Rezoning Transportation Analysis

Petition Number: 2022-120

Date	Description
12-29-22	First Review (PDM)

1. Curblin:

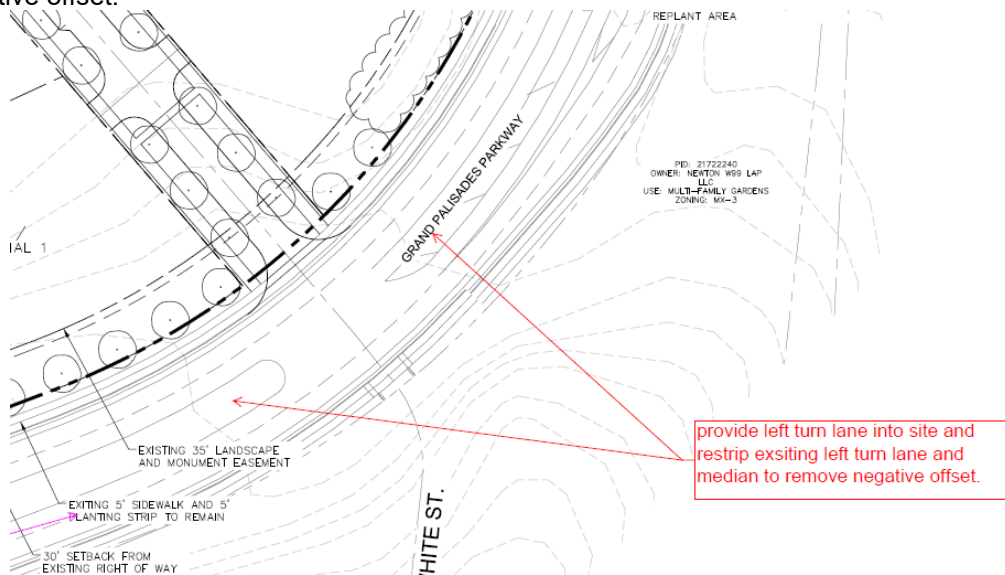
Label and dimension the curb and gutter from the centerline for each road on the site plan.
